Planning Commission Staff Report

Description: **Timberlake Corporate Center, Sign Package**: A request for a Sign Package to establish sign criteria for the Timberlake Corporate Center development located on the north side of N. Outer 40 Rd., east of Timberlake Manor Parkway.

TIMBERLAKE CORPORATE CENTER
SIGN PACKAGE APPLICATION

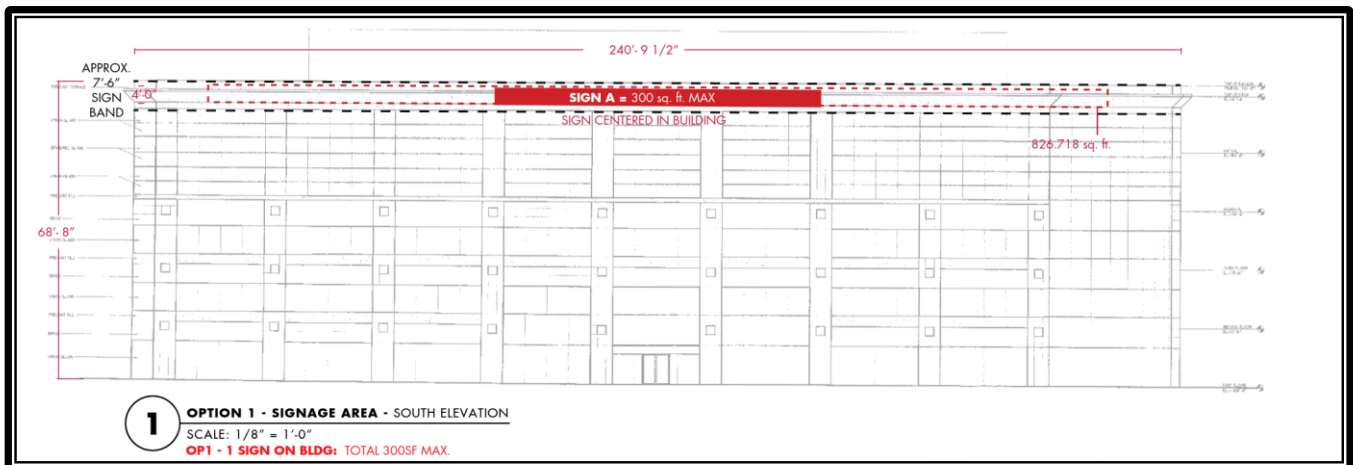
Project Identification Signs: The proposal is consistent with the requirements of the Unified Development Code. A single commercial or industrial development or subdivision which is in excess of 20 acres in size is permitted a project identification sign at each main entrance to the development. These signs are typically used for identifying the name of the project and/or containing a directory of tenants. Signs are permitted to be up to six feet in height and no more than 50 square feet in outline area. The sign package proposes to retain the existing signage and locations and incorporates these requirements into the sign package. Locations of the two signs are shown below.

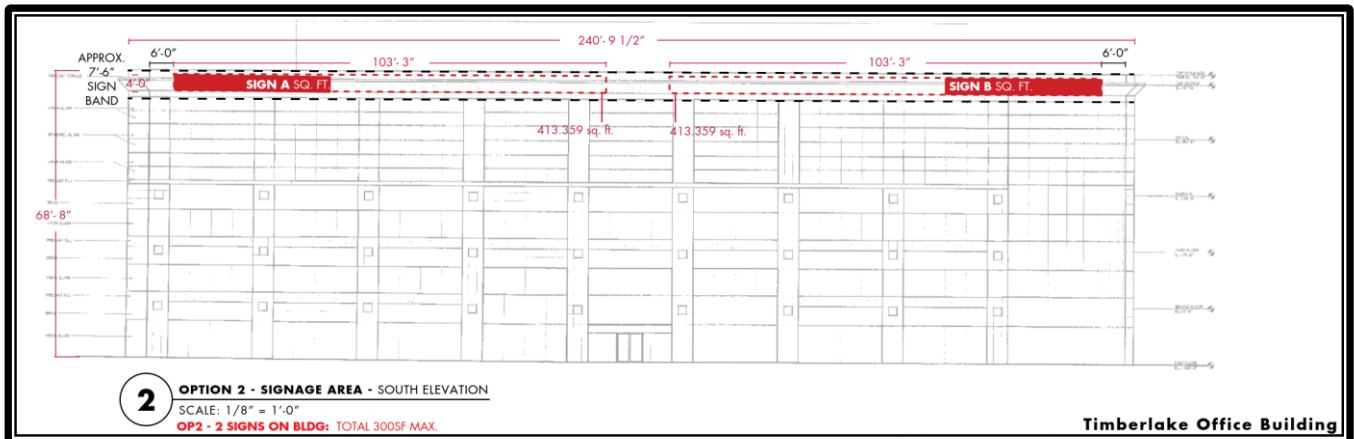
The request by the applicant seeks to modify the location and number of wall signs permitted. Under the proposal, the applicant would have the flexibility to install one or two signs on the southern façade of any building. If only one wall sign is utilized, the proposal would be compliant with the UDC regulations, allowing a maximum sign area of 300 square feet or 5%, whichever is less. Wall signs are proposed to be located within a sign band area shown below.

If two signs are installed, they would be on opposite ends of the façade, still within a defined sign band. Total sign area for each building shall not exceed 5% or 300 square feet, whichever is less (i.e. the combined sign area will not exceed 300 square feet). As a tradeoff, the sign package proposes that no other facades would be permitted additional wall signs, so no wall signs would be permitted on the north, east, or west facades.
